# Access Compliance Report

## Public Rights-of-Way

### (Curb Ramps)

Intersection ID: 52600	Main Street: MCCULLOUGH_DR	Cross Street: IKEA_BV	Location: NW
ADA ID: F1E12B8E6E87	Ramp Type: Perp	Initial Pass/Fail: Fail	Overall Compliance: No
Severity Score: 10			
Codes/Mitigation Info/Possible Solution		Field Measurements/Component Compliance

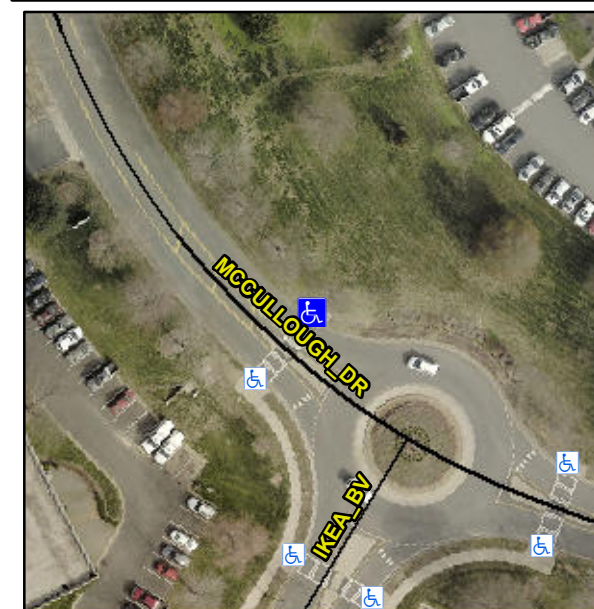
**Not Found, R304.5.1**

Compliance	Description	Data	Compliance	Description	Data
N/A	Ramp Length (in)	72.0	Yes	Ramp Slope (%)	7.2
No	Ramp Width (in)	47.5	Yes	Ramp XSlope (%)	2.2
N/A	Flare Type LT	N/A	N/A	Flare Type RT	N/A
N/A	Flare Slope LT (%)	N/A	N/A	Flare Slope RT (%)	N/A
N/A	Flare Traversable LT?	N/A	N/A	Flare Traversable RT?	N/A
N/A	Landing Length (in)	N/A	N/A	DWS Provided?	N/A
N/A	Landing Width (in)	N/A	N/A	DWS Contrast?	N/A
N/A	Landing Slope (%)	N/A	N/A	DWS Length (in)	N/A
N/A	Landing X Slope (%)	N/A	N/A	DWS Full Width?	N/A
N/A	Landing Curb? (Y/N)	N/A	N/A	DWS Offset (in)	N/A
N/A	Shared Landing?	N/A			
N/A	Gutter Ponding?	N/A	N/A	Gutter Slope (%)	N/A
N/A	Gutter Lip Ht (in)	N/A	N/A	Gutter X Slope (%)	N/A
N/A	Painted X Walk1?	Yes	N/A	Painted X Walk2?	N/A
	X Walk 1 Direction	To SW		X Walk 2 Direction	N/A
N/A	X Walk 1 Width (in)	111.0	N/A	X Walk 2 Width (in)	N/A
	X Walk 1 Slope (%)	1.5		X Walk 2 Slope (%)	N/A
	X Walk 1 X Slope (%)	4.1		X Walk 2 X Slope (%)	N/A

**Remove & Replace Entire Ramp.**
